25 August 2026

COAST PROTECTION BOARD Development Applications
Email:
DEW.CoastProtectionBoardDevelopmentApplications@sa.gov.au
www.environment.sa.gov.au

Development Application No	26016431
Applicant	Australian Naval Infrastructure & ElectraNet
Description	Alterations and extension to Pelican Point Substation & new substation east of Lefevre Substation including undergrounding of 275kV electricity transmission lines
Zones / Overlay	Strategic Employment, Coastal Waters and Offshore Islands, Conservation, Open Space & Ports Sub-Zone / Coastal Areas Overlay
Location	Osbourne & Outer Harbour: - CT 6231/3, D121984 AL506 - CT 6011/467, D76309 AL22 - CT 6316/815, D136949 AL 3003 - CT 6322/501, D52266 AL28 - CT 6322/502, D52266 AL29
Council	City of Port Adelaide Enfield

Figure 5 – Lefevre East Substation (Stormwater Management Plan)

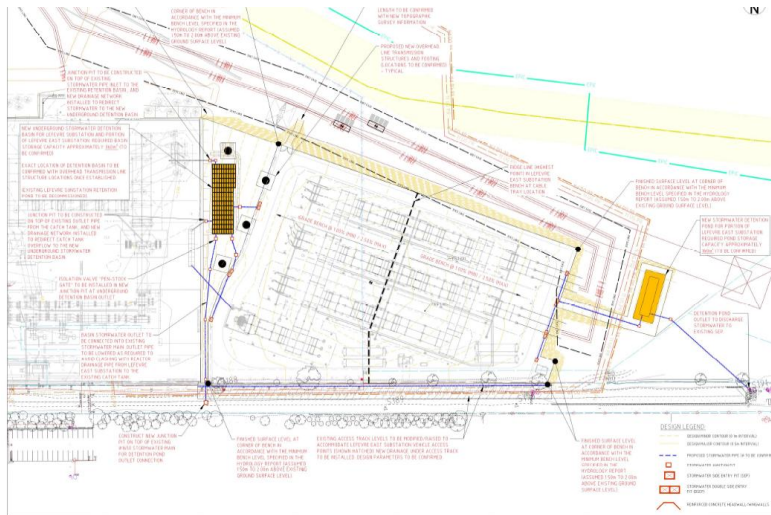
To facilitate an increase in runoff at the Lefevre site the existing retention pond (between the existing and proposed substation) would be transformed into a new underground On-Site Detention basin (OSD), including a new detention pond east of the new substation. The site would then be connected via an array of underground pipe networks, that divert stormwater runoff to the detention ponds/basins, before being directed to the stormwater mains south of the site where it is then discharged into the Port River.

The pollutants and contaminants associated with the site are deemed to pose minimal risk to the sensitive receiving environment and consist of mainly dust, with the oily water reactor at the new substation to be bunded and directed to the existing oil/water separator tank at the existing substation. The controlled runoff via an underground pipe network minimises surface related erosion and sediment mobilisation, with the detention ponds/basins facilitating water quality treatment before being discharged.

In the event the downstream stormwater mains become blocked, the new OSD will safeguard the site by allowing overflow north through Grated Inlet Pits into the adjacent Mutton Cove vicinity. Applicant information indicates the overflow path associated with the existing retention basin *"could not be identified"*, and as such is assumed that uncontrolled overflow and runoff occurs during intense rainfall events, which can cause erosion and mobilisation of sediments. The proposed stormwater management plan minimises the occurrence and utilisation of this overflow pathway, provided the downstream stormwater main is maintained before the wet seasons of winter/spring (June to August).

The basin also incorporates an extra protection layer in the form of a shut off valve at the outlet for emergency scenarios (e.g. reactor fire), which will be lined to prevent contamination of the below soil profile/groundwater. In the event of a reactor fire requiring the isolation valve to be shut, the site and OSD shall be cleaned/flushed prior to reopening the valve to prevent any contaminants entering the Port River. The Board notes the implementation of a sediment, erosion and drainage management plan (SEDMP) at the Pelican Point site and advises that due to the sensitive nature associated with the surrounding environment at the Lefevre site, a SEDMP needs to be implemented during the construction phase to alleviate the potential for erosion and sediment mobilisation into the Port River and adjacent Mutton Cove.

Upon the request of the applicant the City of Port Adelaide Enfield Council suggested finished bench levels between 3.1m and 3.35m AHD for the Lefevre East Substation, with finished bench levels to be approximately 1.5m to 2.0m above current existing ground surface levels for the site. The applicant has indicated that bench levels will be dictated by sea level rise and climate change factors and are to be confirmed by Hydrology Reporting.

The development should ideally comply with the Boards recommended levels. Where minimum finished floor levels are not achieved the Board requires that all mechanical, chemical and electrical equipment vulnerable to water ingress be raised to a minimum level of 3.55 metres AHD.

- In the event of a reactor fire requiring the isolation valve to be shut, the site and OSD shall be cleaned/flushed prior to reopening the valve to prevent any contaminants from entering the Port River.
- A sediment, erosion and drainage management plan (SEDMP) shall be implemented at the Lefevre site during the construction phase, to alleviate the potential for erosion and sediment mobilisation into the Port River and adjacent Mutton Cove.
- Where minimum finished floor levels are not achieved, the Board requires that all mechanical, chemical and electrical equipment vulnerable to water ingress shall be raised to a minimum level of 3.55 metres AHD.
- Any imported substrate material or engineered fill shall be free of weeds and pathogens.

Figure 6 – Pelican Point Substation (Stormwater Management Plan)

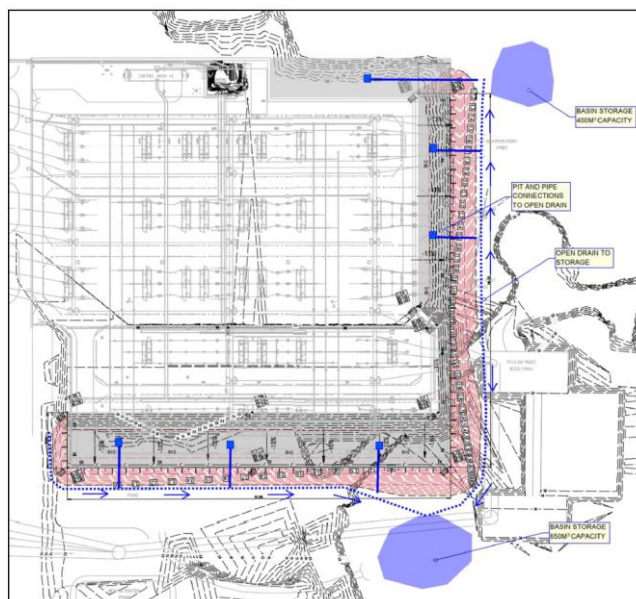
Applicant information also indicates that the Pelican Point site currently has minimal stormwater management infrastructure with runoff flowing overland to trapped low points located north east and south east of the site, where it is retained and dispersed via infiltration and evaporation. The proposed stormwater management plan will direct stormwater via pits, pipes and open drains to existing low lying areas that act as a storage basin. The applicant has indicated that sufficient space exists in the low lying area for a formalised basin if required. The Board considers the surrounding environment at Pelican Point to be industrialised, and poses minimal risk, as no formal stormwater mains are present that could potentially introduce runoff into the Port River. Council should determine whether formalised basins are required to safeguard the surrounding site.

Application information indicates that the Pelican Point substation extensions will have a finished floor level comprised of a 1% paving gradient from 3.3m to 3.76m AHD. A portion of the site is deemed to be compliant with the minimum finished floor levels for this location.
